Official Transcript of Proceedings  
NUCLEAR REGULATORY COMMISSION

Title: Advisory Committee on Reactor Safeguards  
ESBWR Subcommittee

Date: Tuesday, November 17, 2009

# ESBWR Containment

Figure 9. NC Gas Pressures in DW Annulus, DW Head and GDCS Gas Space

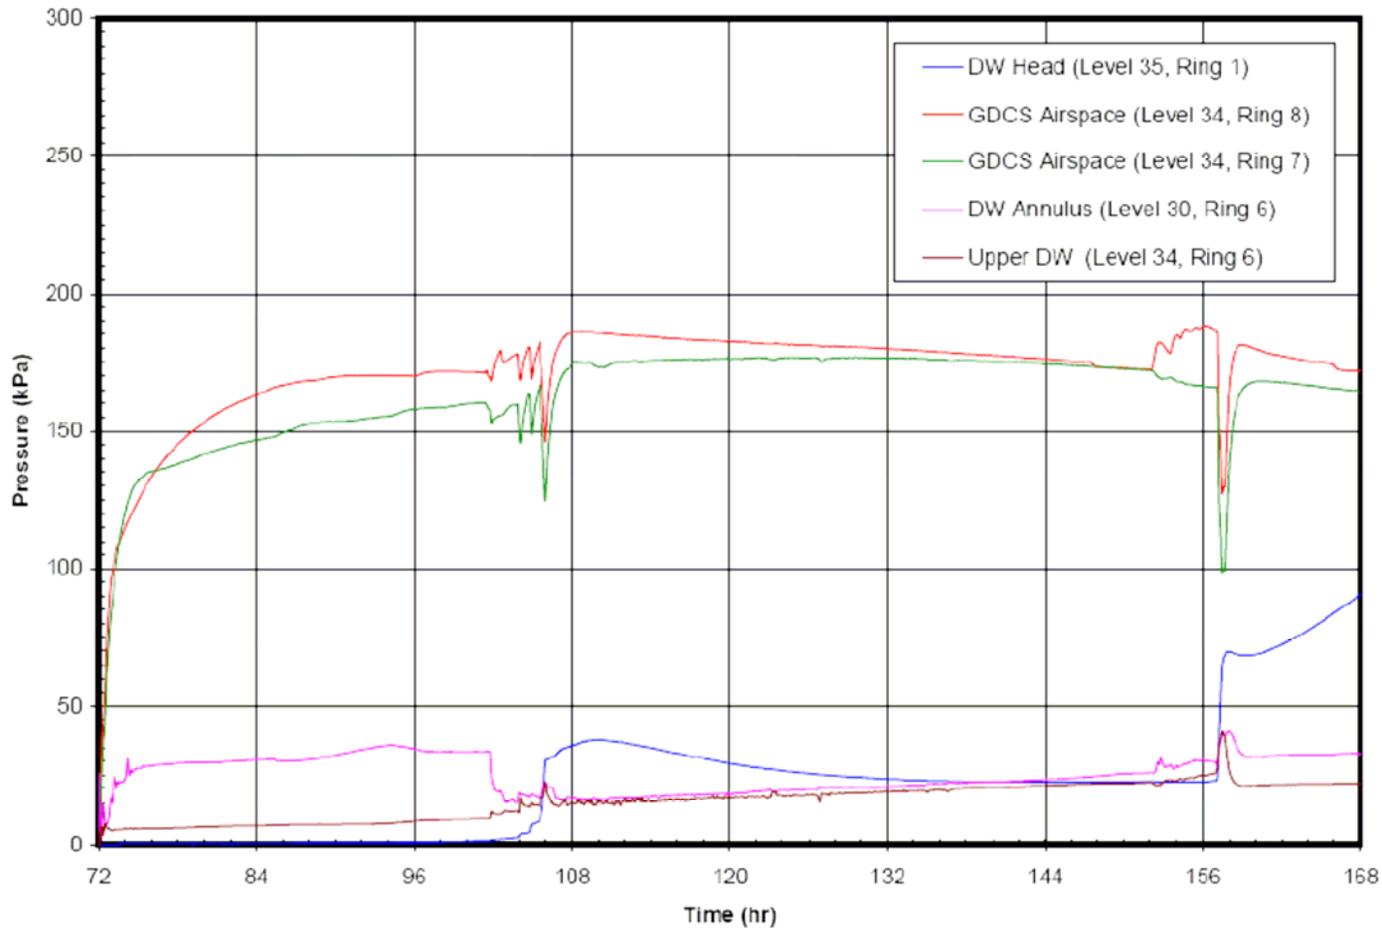
22 One of the ACRS consultants noted an  
23 error in the plot of noncondensable gas pressure, an  
24 RAI response. The upper drywell, which is Level 34,  
25 Ring 6 had been plotted as zero noncondensable

20 CONSULTANT WALLIS: Level 34; I had a lot  
21 of trouble figuring out where it is. It's not labeled  
22 in one of your figures you showed in July. And as  
23 this is drawn, it seemed to be at the top of the RPV,  
24 which is actually way up in the head. It doesn't  
25 make sense to me. So part of my question at that time

4 CONSULTANT WALLIS: That's why I didn't  
5 understand where the gas came from at 104 hours, or  
6 something. There's a big squirt of gas into the  
7 drywell head. There's no gas in the drywell head at  
8 all until about 100 and something hours, isn't that  
9 correct? That curve that you've now corrected or is  
10 it in there?

12 CHAIR CORRADINI: Okay. So just to  
13 repeat: There's connection via the equipment hatches  
14 to the rest of the drywell. There's pressure  
15 equalization connection to the upper GDCS airspace  
16 via this piping. And Graham's question is at 104  
17 hour what's happening that you get this bump in  
18 noncondensable gas.

1 partial pressure. And we've corrected that plot and  
2 provided a revised RAI response to the staff.

# RAI 6.2-139 -Corrected

## Level 34, Ring 6 curve on Figure 9

Figure 6.2-140 S04-C1 Main Steam Line Break, 1 DPV Failure (Bounding Case) – Containment Pressures (30 days)

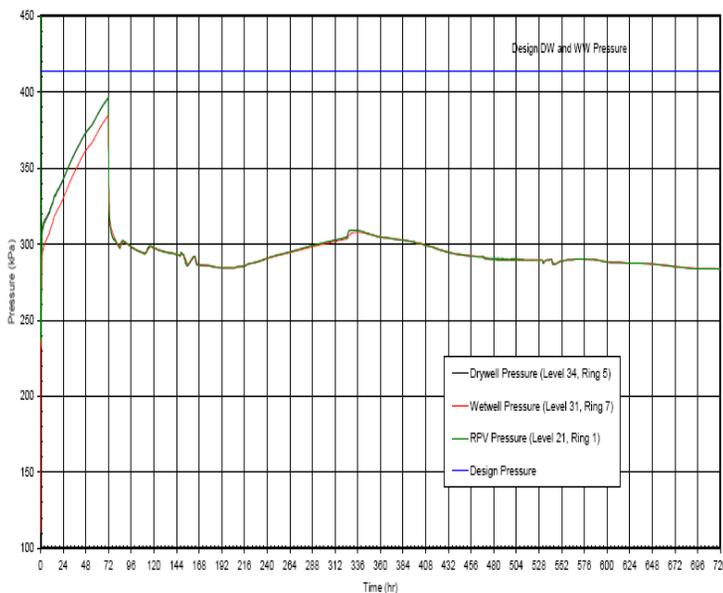
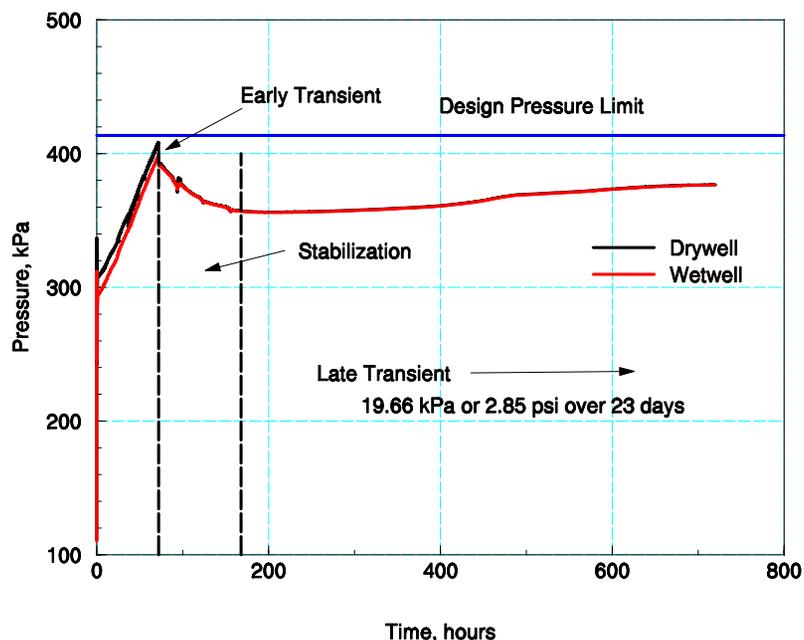
15 CONSULTANT WALLIS: Can I ask something  
16 now? When I looked at this 300 cfm at 2400 which is  
17 the text of an RAI, it agrees with the table you just  
18 gave me. But when I looked at the figure in S04D6 I  
19 got half the pressure drop at that flow rate. So  
20 something was inconsistent. Should I now throw away  
21 S04D6 and there's a new response which supersedes it?

4 CONSULTANT WALLIS: That's good. But now  
5 if I look, I don't have a computer. My colleagues  
6 have a computer. If they look at S04D6, figure 6.2-  
7 140 will they find a curve that's compatible with  
8 this table or will they find something which is not?  
9 Because when I looked at it in the paper version I  
10 found it incompatible.

18 CHAIR CORRADINI: But what we have here  
19 is the fan curve, which I finally found, on S02D6 is  
20 not compatible for the S04; for the figure of the fan  
21 curve you got in the S04 response is not compatible  
22 because it had been superseded by your most recent  
23 response, is that correct?

4 MR. MARQUINO: Yes, the pressure response  
5 of this figure is superseded by the 6.2-140 figure in  
6 DCD Rev 6 figure.

6 The figure that we sent to NRC for 6.2-  
7 140 S05-C4 is the latest and it has the corresponding  
8 noncondensable pressures in the drywell and GDSC  
9 airspace.
